Date Created : 2008/05/08
Date Issued On : 2008/05/14
PCN# : Q2081905

INFORMATION ONLY NOTIFICATION

This is to inform you that a minor change is being made to the following product(s). This notification is for your information only.

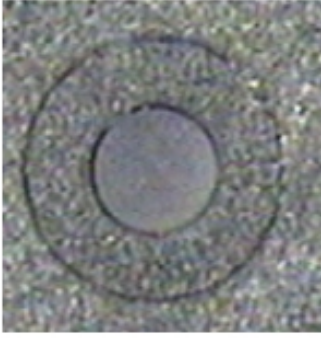
Description of Change (From): Package retract pin hole shape Retract pin D=1.4mm

Description of Change (To): BUSH type for retract pin hole D(with bush)=2.0mm,
D(pin)=1.0mm

Reason for Change : Prevent retract pin fast worn out, improve the part life
